BRE Review of Wind Assessment in Respect of Outline Planning Application 200328 at Vastern Court, Caversham Road, Reading

2. Review of the Technical Appendix 9.1 Wind Microclimate prepared by Xi Engineering Consultants Ltd

Figure 5 Comparison between Figure 11 (wind comfort) and Figure 16 (wind safety)

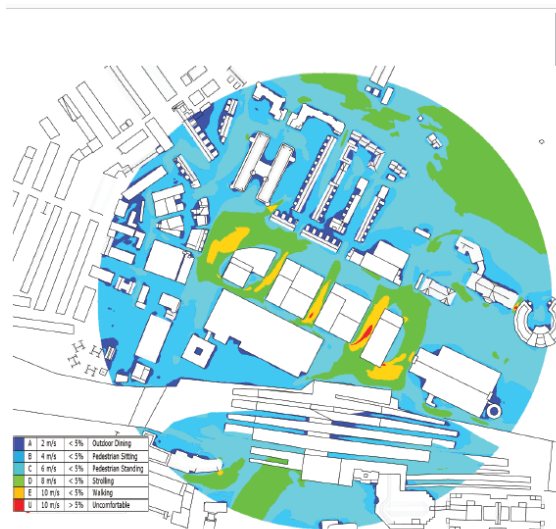
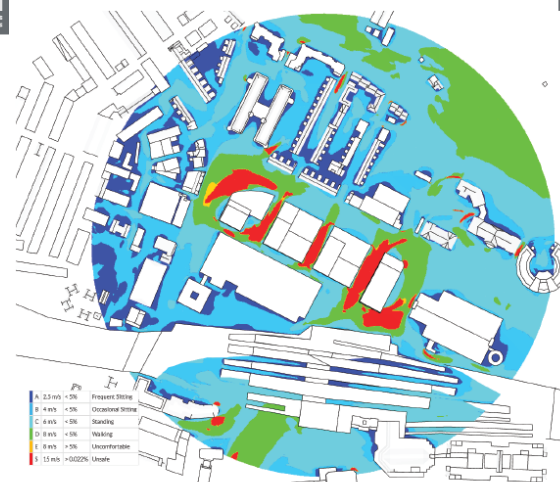
Some of the results are unexpected. For example Figure 11 shows that the wind conditions at ground level in the gaps between the proposed buildings are generally suitable for walking or strolling, but Figure 16 shows that the wind conditions in these same areas are mostly unsafe, see Figure 5 below which shows a comparison of these figures. Also, compare the 'unsafe' conditions shown in Figure 15 to the North the site (e.g. between the existing low-rise buildings and in an open space to the East of the lines of terraced buildings) with Figure 10 where these zones are suitable for 'strolling' and 'pedestrian sitting'. These inconsistent results suggest that there is something wrong with the approach being used. **BRE Comment: Please check and confirm that the results are correct.**

7.0 & 8.0	Clarification	There is a potential lack of correlation between some wind comfort and wind safety results. Please check and confirm that the results from the CFD analysis are correct.
